# HISTORIC DISTRICT COMMISSION ADDITIONAL INFORMATION REQUEST

**Application Number:** HDC2025-00729

<b>NAME:</b> Peter Markaj		<b>COMPANY NAME:</b> N/A	
<b>ADDRESS:</b> 2050 Atkinson	<b>CITY:</b> Detroit, Michigan 48206	<b>STATE:</b> MI	<b>ZIP:</b> 48206
<b>PROJECT ADDRESS:</b> 2050 Atkinson			
<b>HISTORIC DISTRICT:</b> Atkinson Avenue

#### SIDE/MAIN ENTRY DOOR

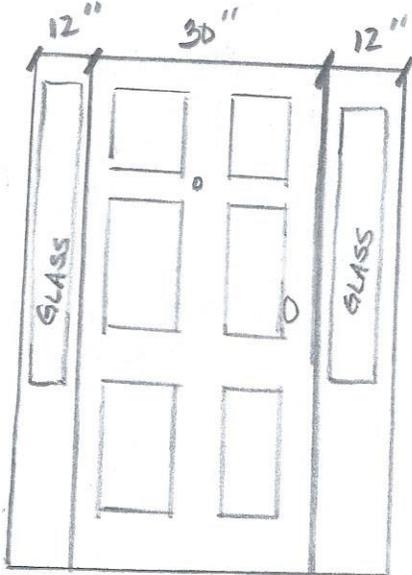
- Cut-sheets of exterior doors – confirming design, material, dimension and finish color
- Cut-sheets for gutters. If you are installing new downspouts, please include that as well. Confirm location of downspouts.

6 PANEL DOOR W/ SIDE LITE FRAME  
 W/ 2' OVERHANG W/ PILLARS

STUCCO  
 ABOVE  
 REAR  
 ENTRY  
 DOOR

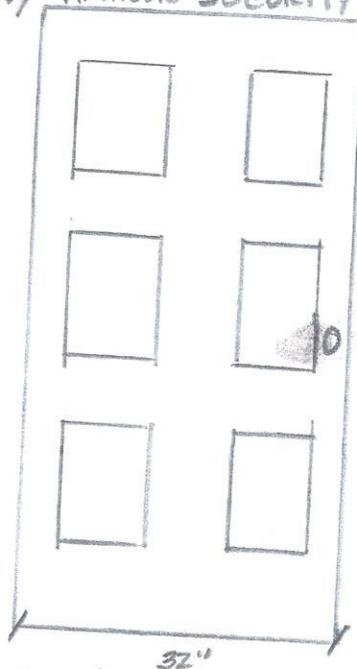
- Draw a square(s) on a rear wall photo showing the specific locations where stucco will be replaced. In writing list that it will be an in-kind repair and new stucco will match existing stucco in material/composition, thickness, surface finish and color.

- \* Main entry door w/12" Sidelite frame to be installed, and new pillars to be installed to support 2' Overhang over side door
- \* Dryvit / stucco will be installed and restored to its original state at the rear of the home and above rear door (white)

4' x 4' W/ 3 STEPS TREATED  
 (WHITE) WITH RAILINGS (SEE DRAWING)

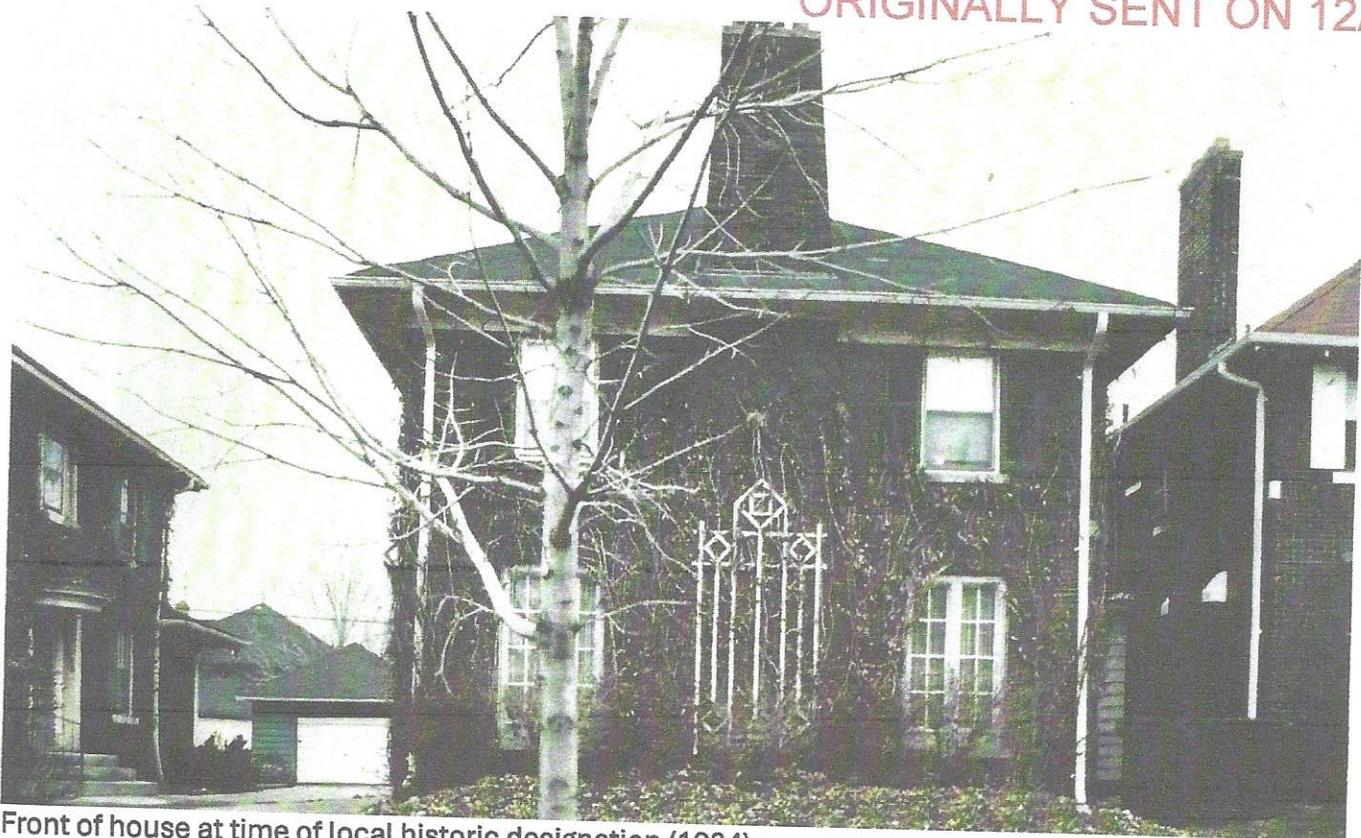
- New stairs at rear of house: Dimensioned drawings are needed (you can use photos and draw the stairs with dimensions on the photo(s) to confirm what is being kept (i.e., roof/upper porch floor, wood support posts and first floor landing?) and how the rear steps and railings will look upon completion, confirming material, design and painted finishes.

- \* Treated wood landing painted (white) will be built and the dimensions are 4' x 4' w/3 steps 7" high. White railings to be installed around landing at rear entry of home
